Office Action Summary

10/027,715

KRAEMER ET AL.

Michael G. Bogart

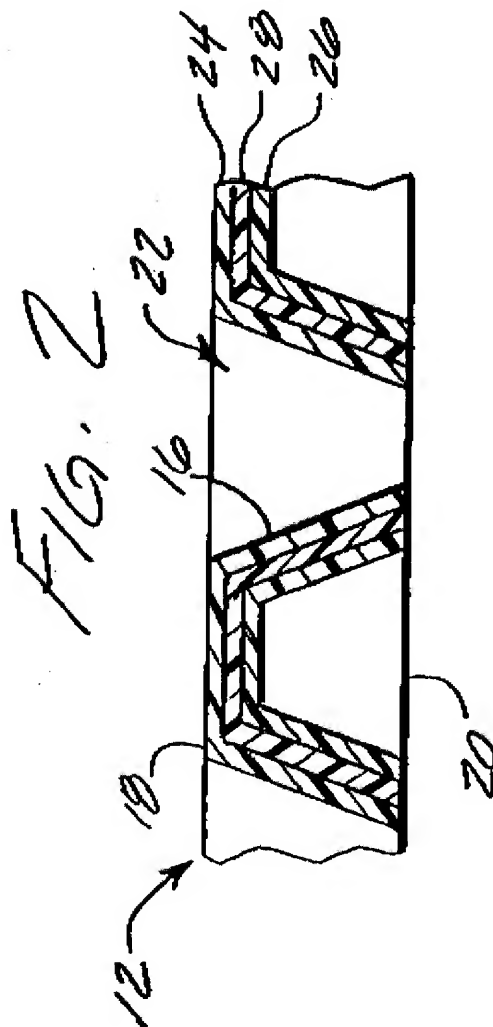
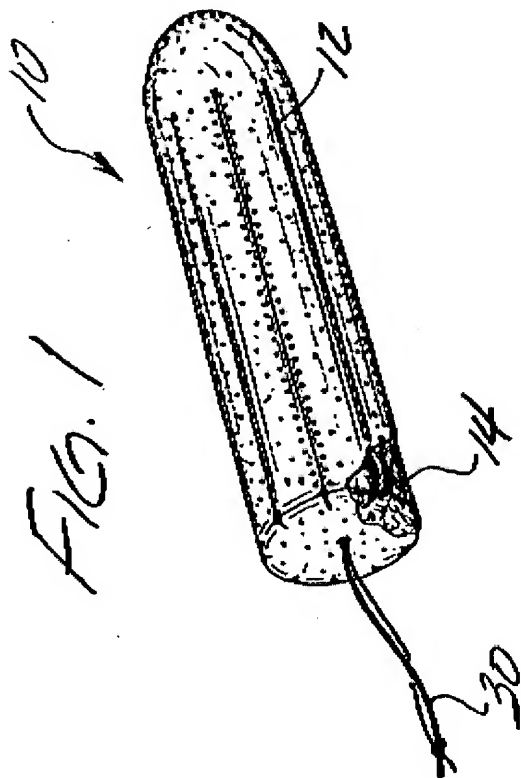
Regarding claim 18, Johnson *et al.* teach an intravaginal device (10) for feminine hygiene comprising a core (14) which is surrounded by a sheathing (12), wherein the sheathing (12)

comprises at least two separate layers of material (24, 26, 28) which at least partially lie one on top of the other and are bonded to one another (see figs. 1 and 2, below)(¶'s 0021-0036).

Regarding claim 28, Johnson *et al.* teach a sheathing (12) comprising three layers (24, 26, 28)(fig. 2).

Regarding claim 43, Johnson *et al.* teach that an insertion end of the device (10) is tapered conically (fig. 1).
